ADDENDUM #2

Reference: Parleys Maintenance Station #234 Improvements
Utah Department of Transportation - Utah
DFCM Project No. 08211900

ADDENDUM NO. 2 to the Contract Documents for the Construction of UDOT Maintenance Station #2434, Parleys Canyon, Utah.

AE312

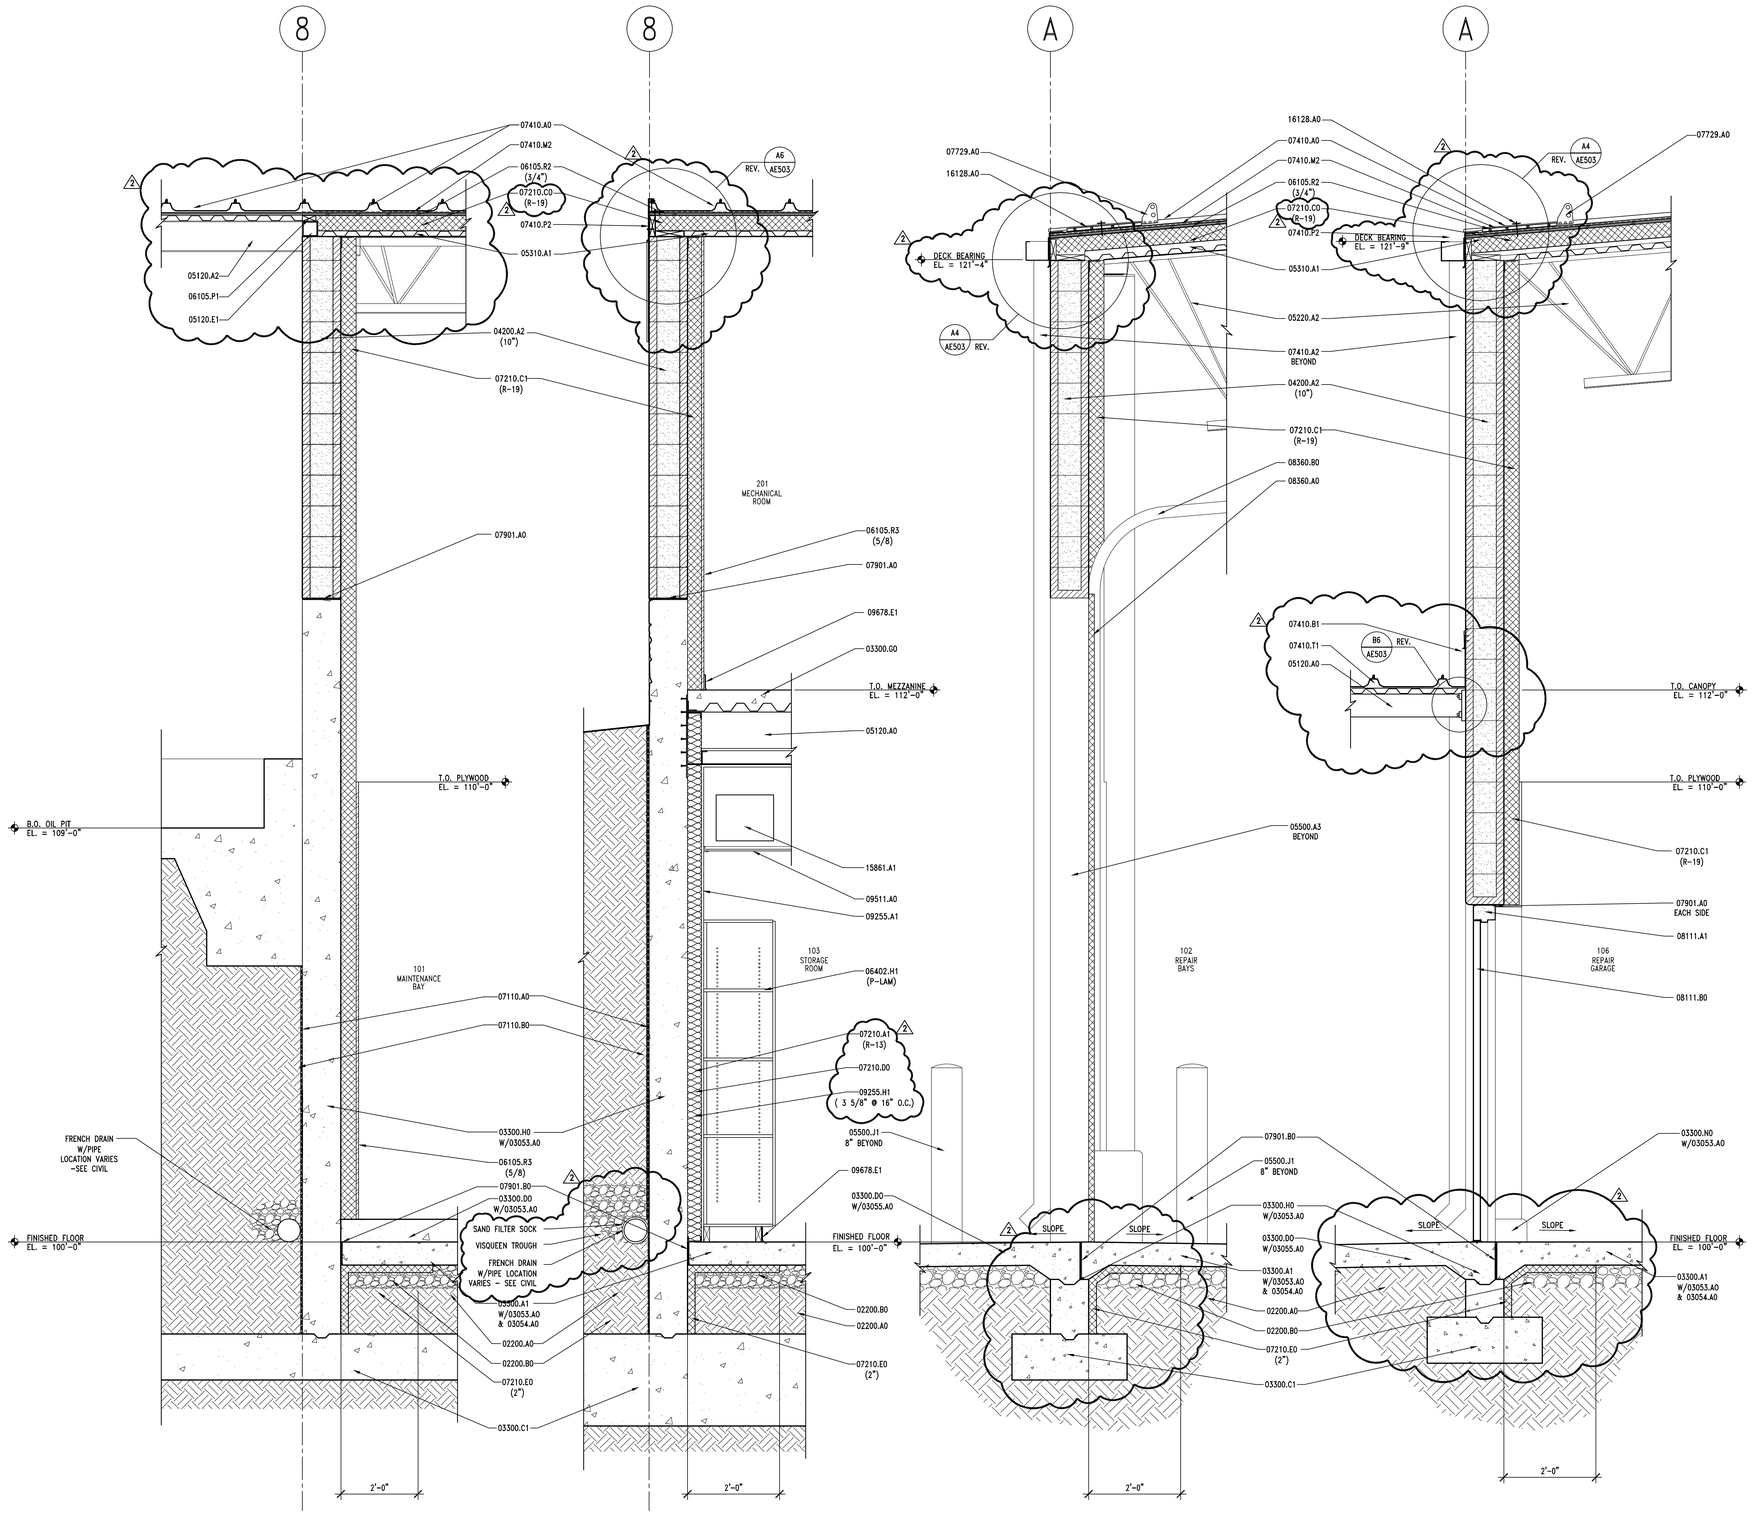
Sheet AE312:

a. Changed Keynote 07210.B1 to 07210.C0.
b. Revised Keynote Legend as indicated.
c. Revised roof edge conditions to match details revised in Addendum #1.
d. Revised oil pit canopy in A1 section to coord. with Structural drawings.
e. Revised french drain in A2 section to coord. with Civil Drawings.

f. Added additional keynotes to A2 section to clarify wall construction.
g. Revised slab condition in A3 & A4 section to coord. with Structural Drawings.
h. Revised canopy attachment in A4 section to coord. with Structural Drawings.
i. Added deck bearing datum to sections.
j. Show location of textured foundation wall on Section A2.

C3 STAIR SECTION/HANDRAIL & ELEVATION

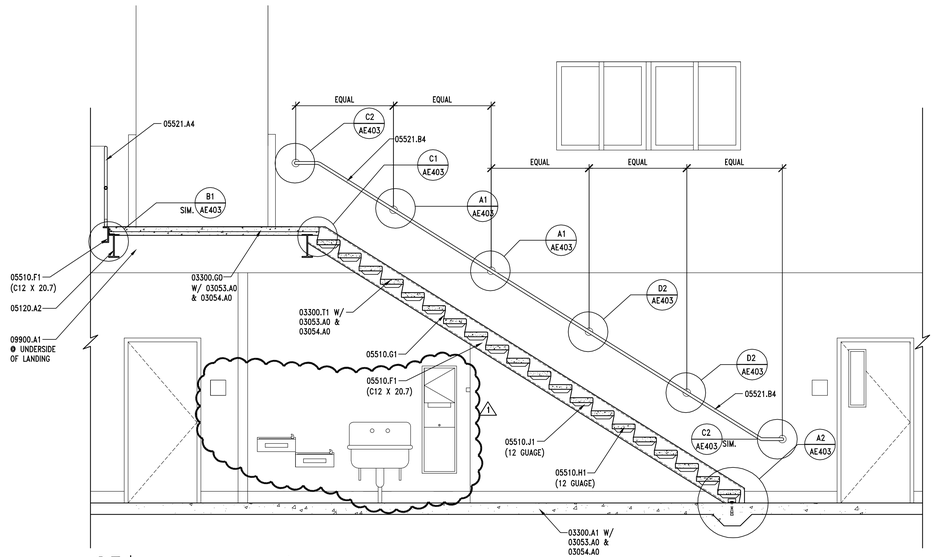
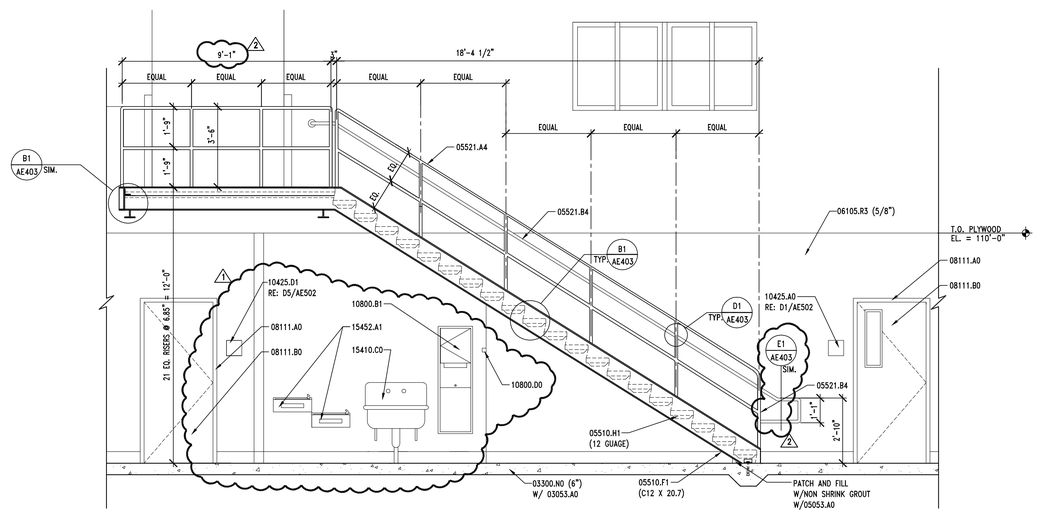
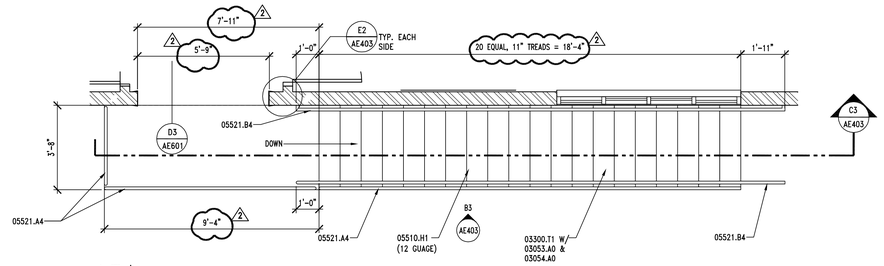
Sheet AE403:

a. Added Detail section callout to B3 section.
b. Added Detail E1/AE403.
c. Revised Stair Dimensions as shown.

A5 | WASH RACK PLAN
AE701 | REF. AE701 | SCALE: 1/4" = 1'-0"

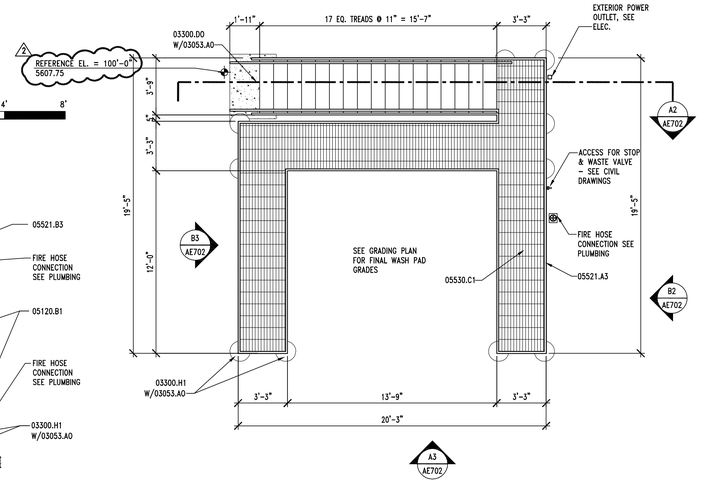
Sheet AE701:

a. Added reference elevation to Wash Rack Plan.

AE703

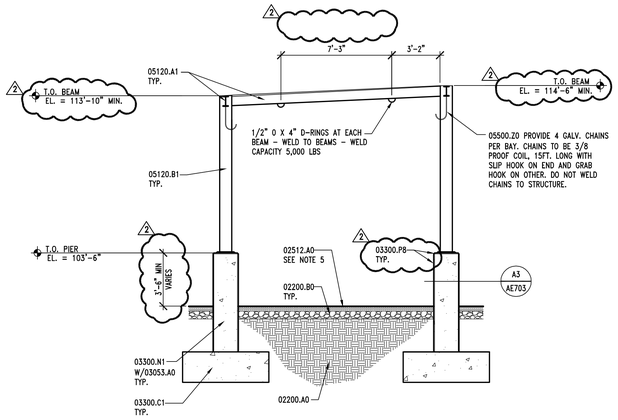
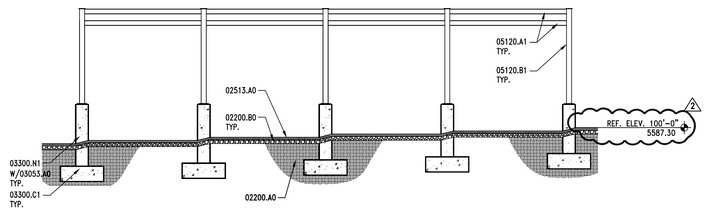
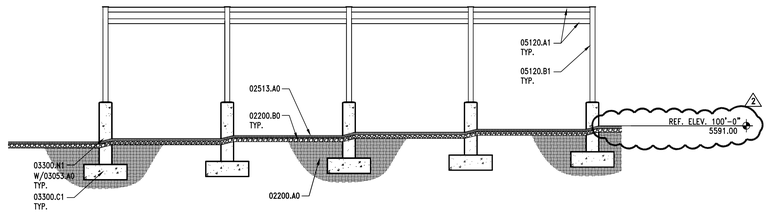
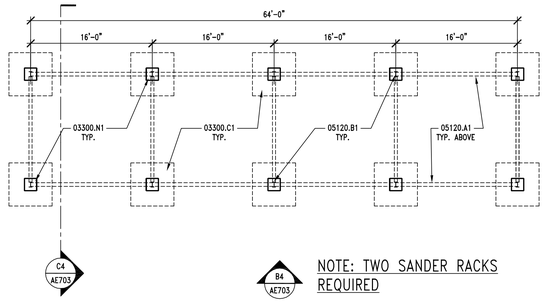
Sheet AE703:

a. Added reference elevations to Sander Rack Elevations.
b. Revised Sander Rack Section to Coord with Structural drawings.

FOOTING AND FOUNDATION PLAN

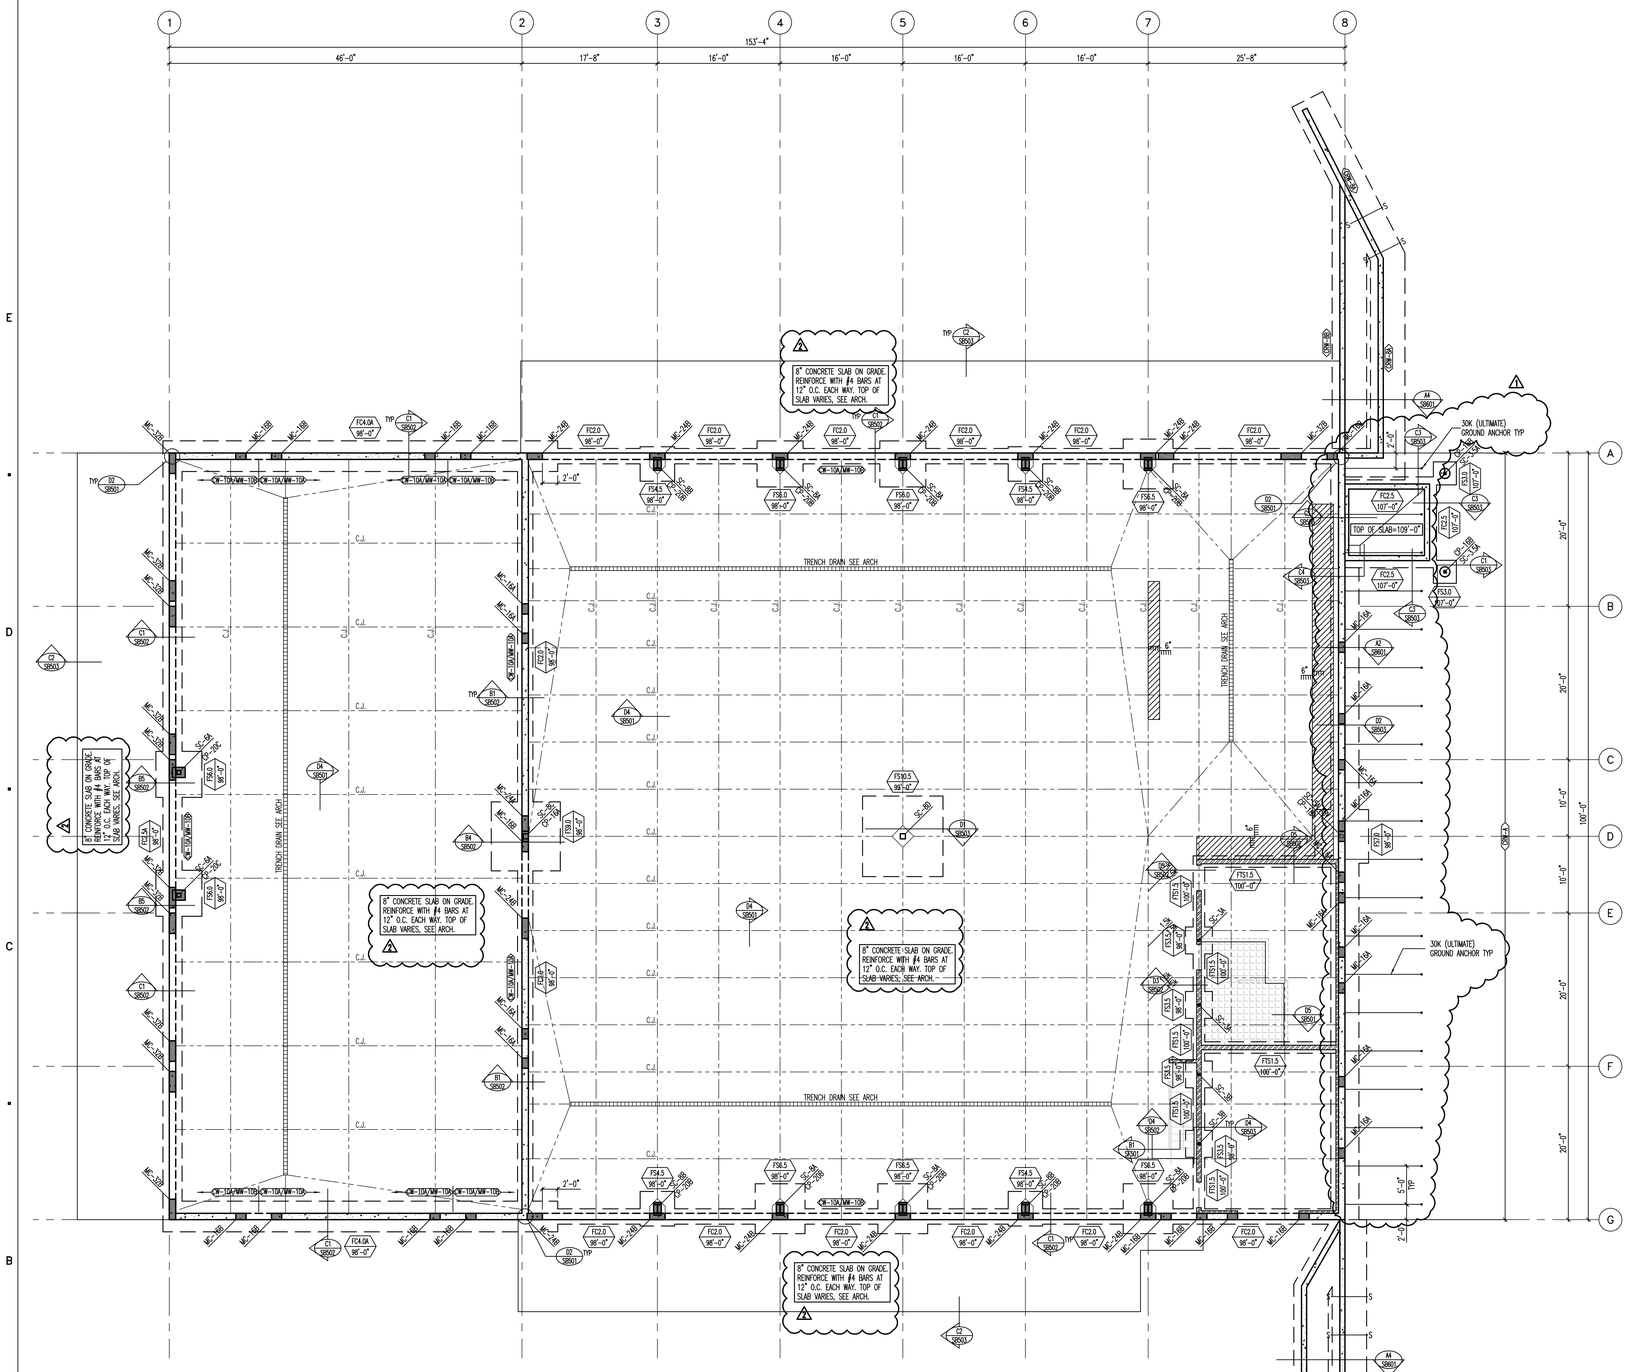
10. Q. SB101 calls for the slab to be 6", with #4 rebar 18" o.c., but the geotech report suggests that the slab be 8", with **epoxy coated** rebar 12" o.c. The sawcut spec also differs, with the drawing showing 8' o.c., and the geotech report calling out 6' centers.

A1. The addendum #2 drawings have been updated to show the slab thickness to be 8" with the #4 rebar at 12" o.c.

A4 CONCRETE RETAINING WALL SCHEDULE-TYP SITE RETAINING WALL

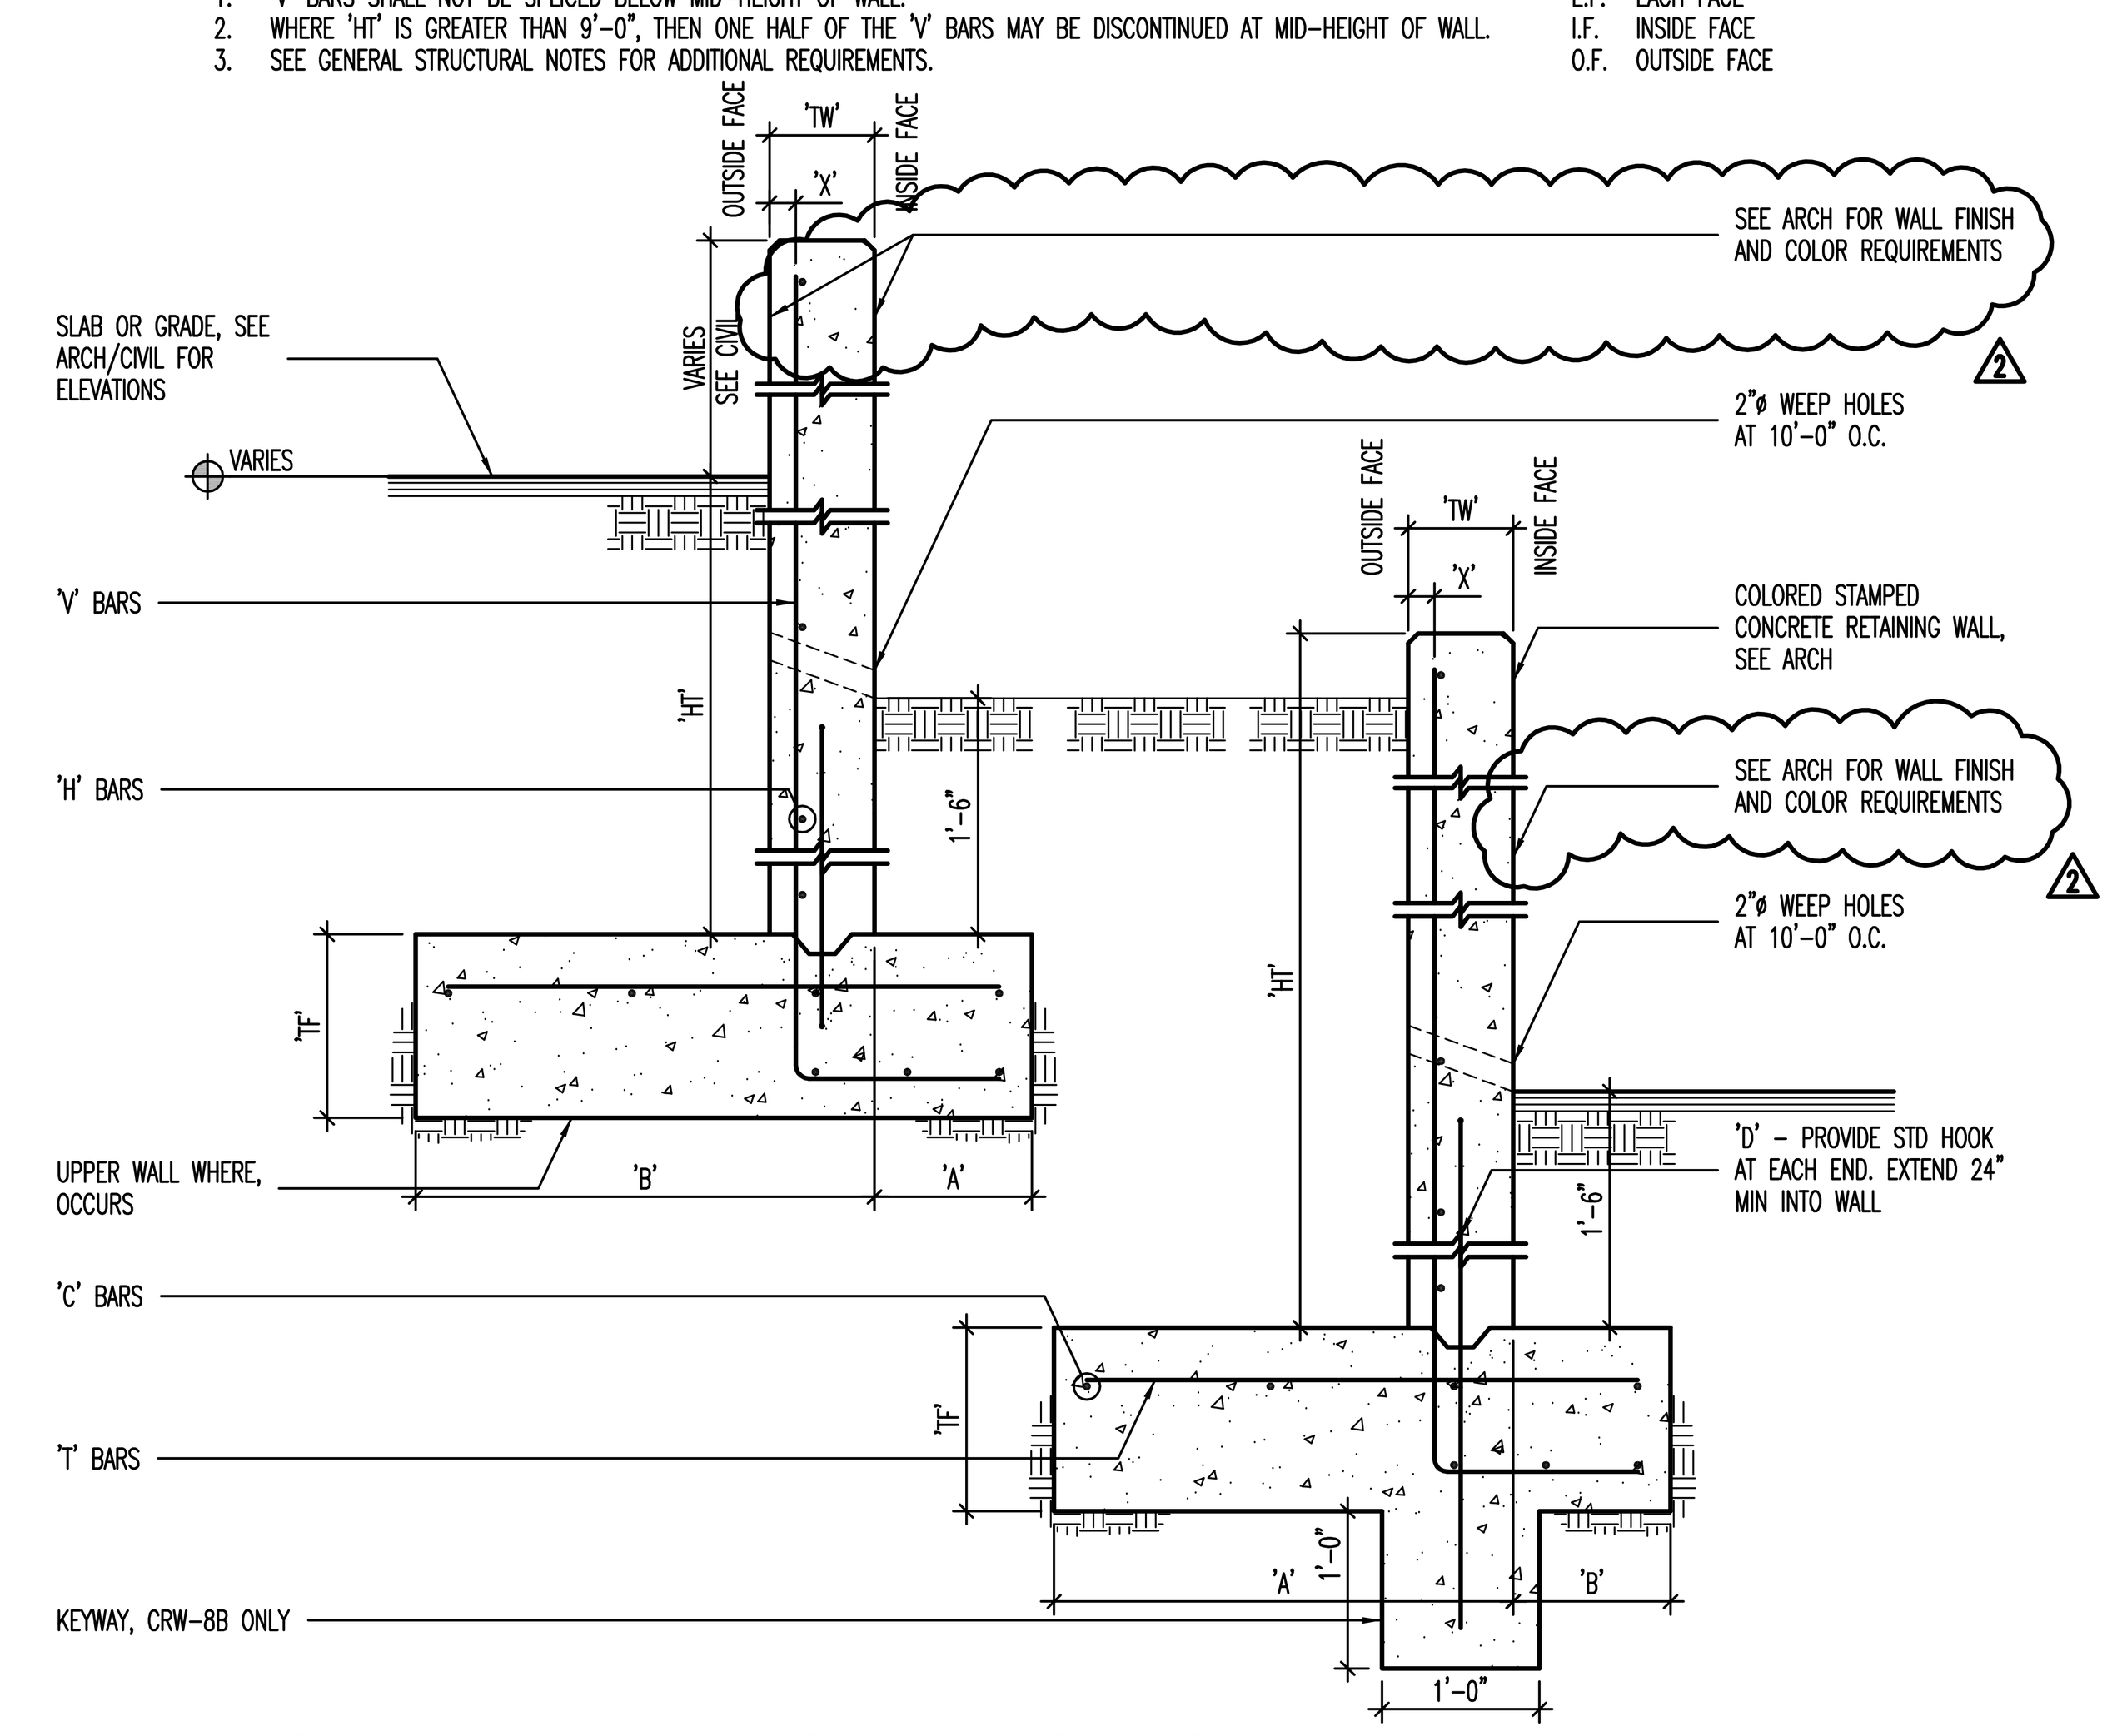
Sheet SB601:

a. Revised reinforcing in detail A2.
b. Revised retaining wall schedule A4 for architectural finish.
